**GENOA CHARTER TOWNSHIP
PLANNING COMMISSION
PUBLIC HEARING
JULY 11, 2022
6:30 P.M.
AGENDA**

Attention:	Kelly Van Marter, AICP Planning Director and Assistant Township Manager
Subject:	St. Joseph Mercy Health System – PUD Amendment and Site Plan Review #3
Location:	7575 Grand River Avenue – north side of Grand River, west of Bendix Road
Zoning:	NRPUD Non-Residential Planned Unit Development

**Re: St. Joseph Mercy Hospital
Site Plan Review No. 3**

DRAWING NUMBER
CS-100

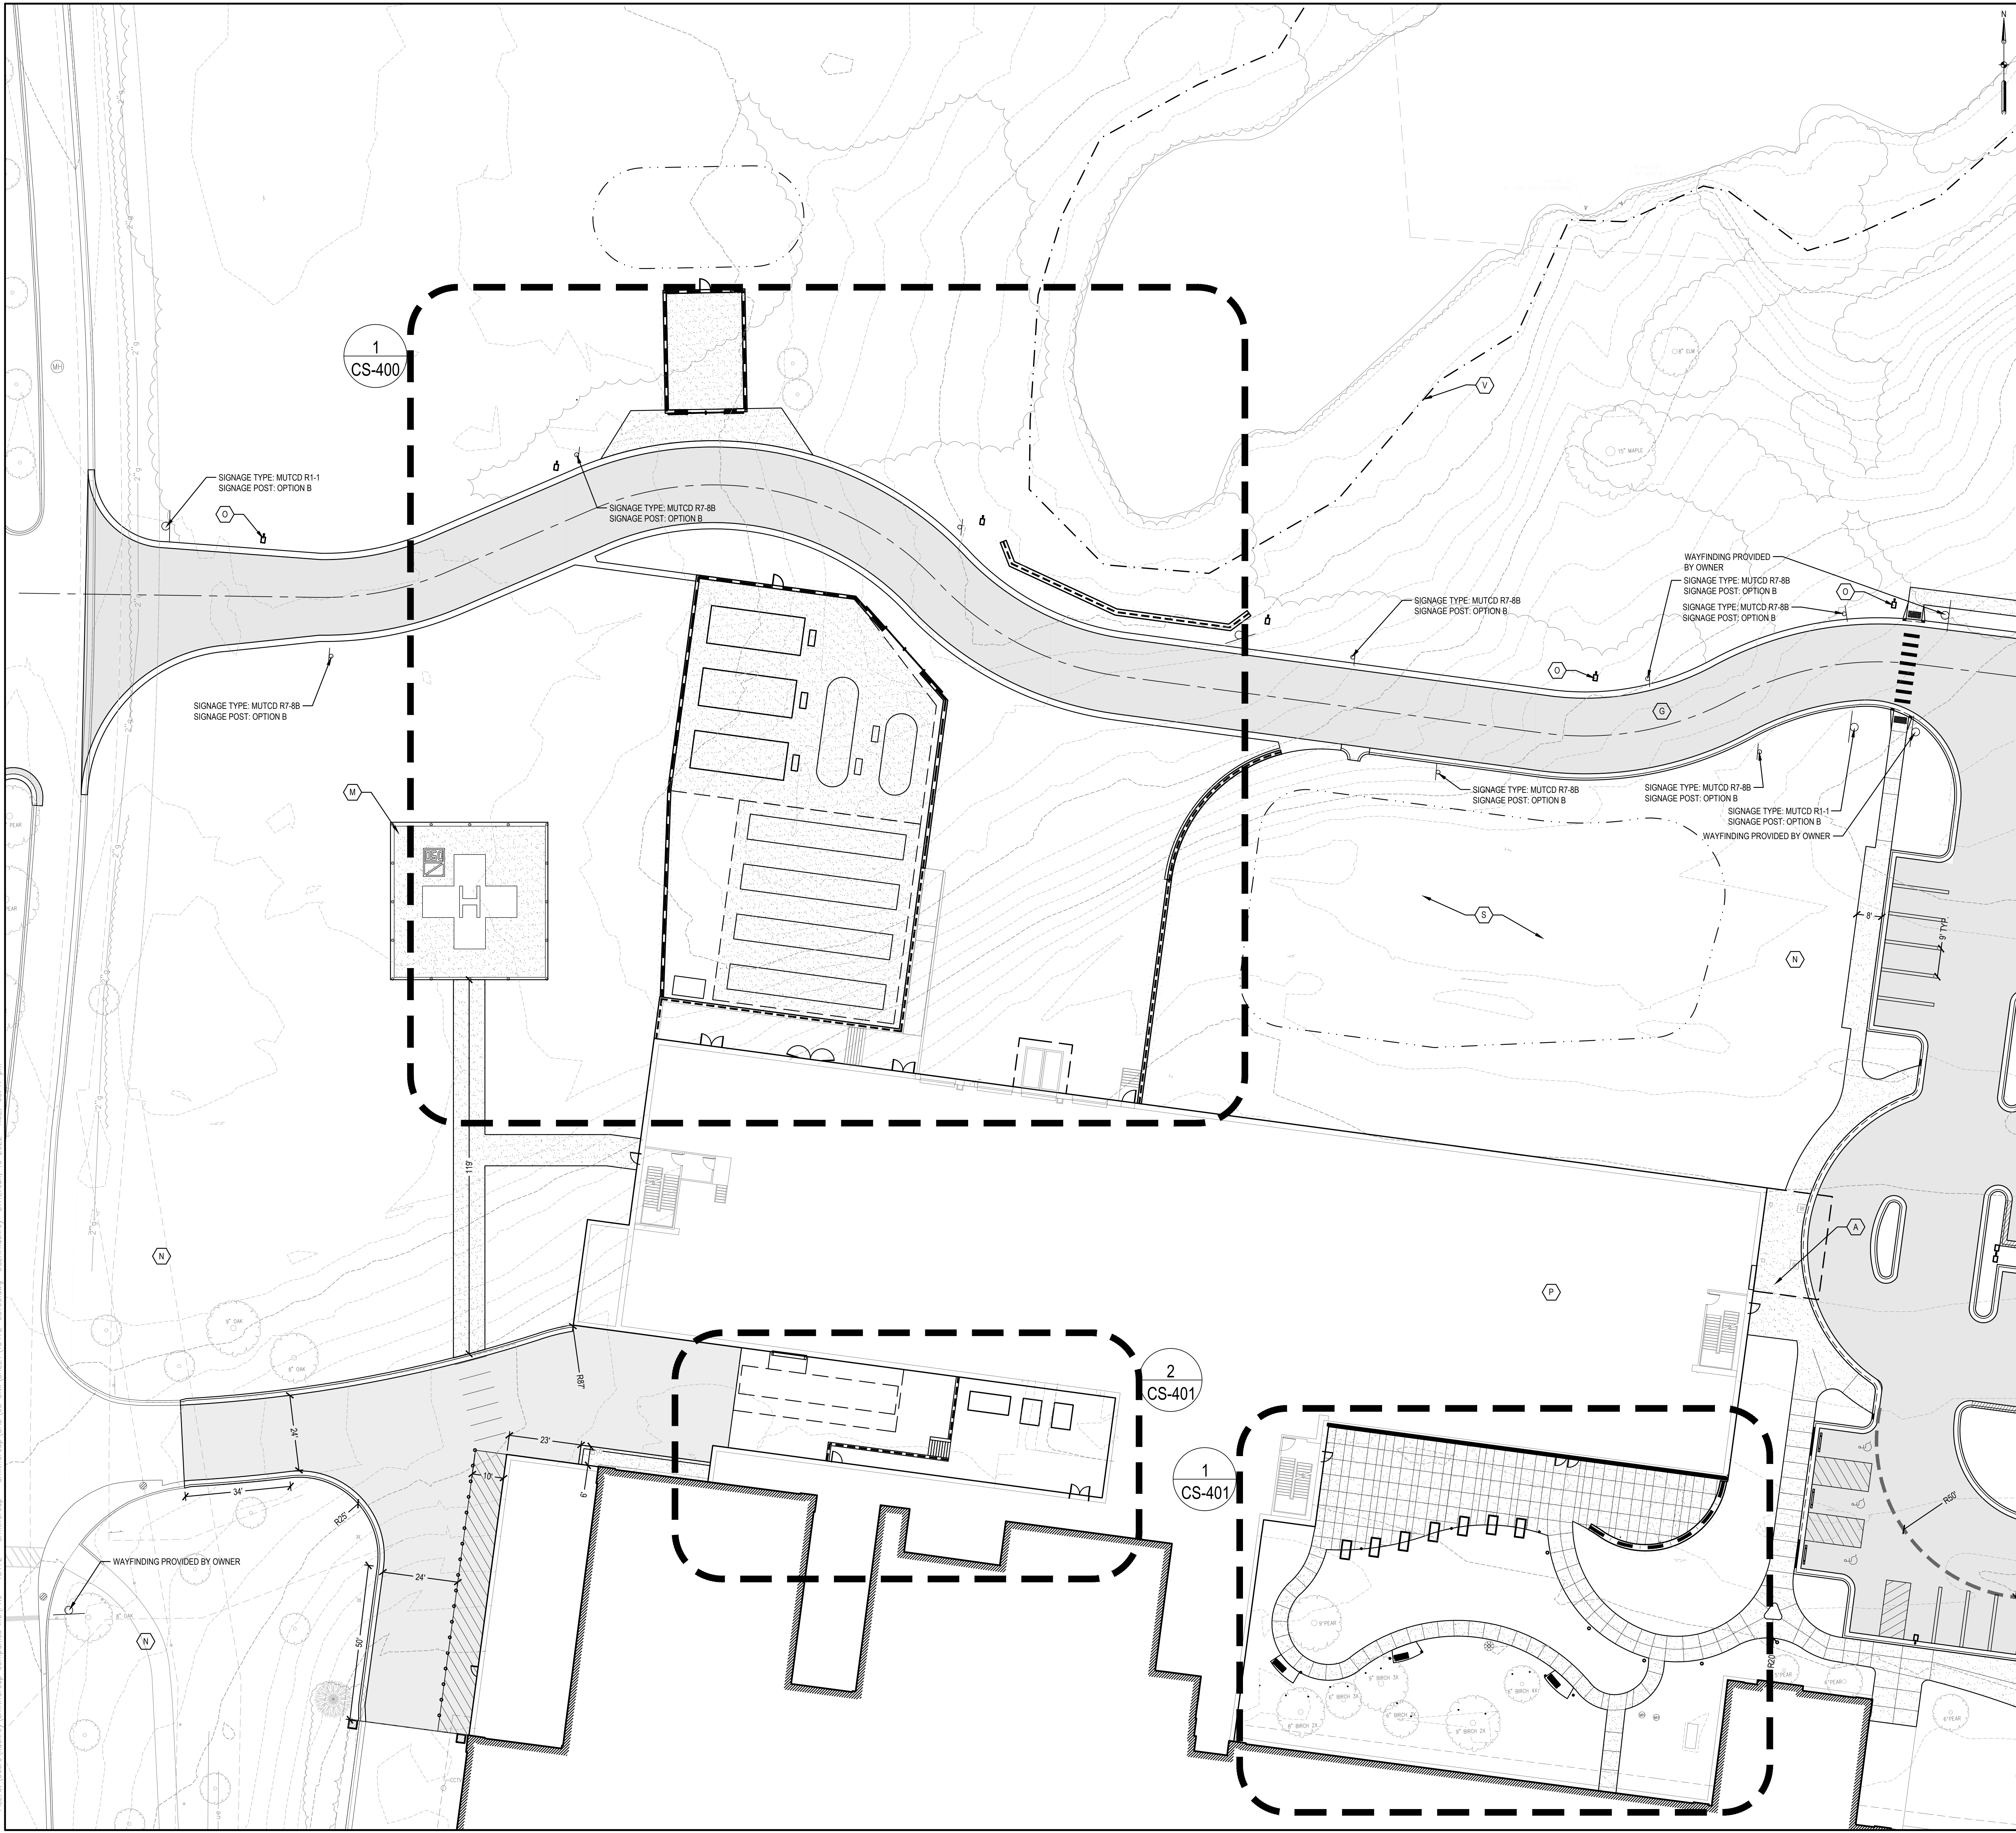
The site plan notes 618 spaces for the anticipated parking needs for the proposal. The plan provides 753 spaces with an additional 246 designed as banked parking (southeast of building).
